Project	IEEE 802.16 Broadband Wireless Access Working Group < http://ieee802.org/16 >	
Title	Fix for Location Update primitive	
Date Submitted	2006-03-07	
Source(s)	ZTE corporation	xu.ling@zte.com.cn
	Xu Ling	
	Mary Chion	
	CATR	
	Gong Daning	gongdaning@catr.com.cn

Re:	Contribution on comments to P802.16g-D1
Abstract	In this contribution, we propose to amend the protocol through add the new message about Location Update
Purpose	Adoption
Notice	This document has been prepared to assist IEEE 802.16. It is offered as a basis for discussion and is not binding on the contributing individual(s) or organization(s). The material in this document is subject to change in form and content after further study. The contributor(s) reserve(s) the right to add, amend or withdraw material contained herein.
Release	The contributor grants a free, irrevocable license to the IEEE to incorporate text contained in this contribution, and any modifications thereof, in the creation of an IEEE Standards publication; to copyright in the IEEE's name any IEEE Standards publication even though it may include portions of this contribution; and at the IEEE's sole discretion to permit others to reproduce in whole

Figure 498— Location Update Primitives

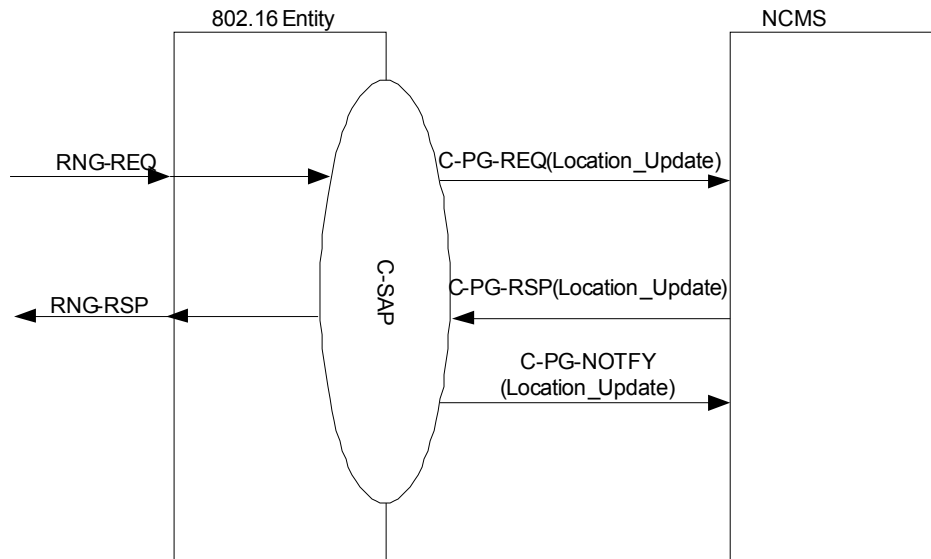
All the above Location Updates are realized by Ranging request/response (RNG-REQ/RSP) message between an MS and a BS, and ~~Location Update request and Location Update response~~C-PG-REQ, C-PG-RSP,C-PG-NOTIFY service primitives are defined between a BS and an NCMS to perform Location Update.

[Modify Location Update flow diagram between NCMS and BS as the following]
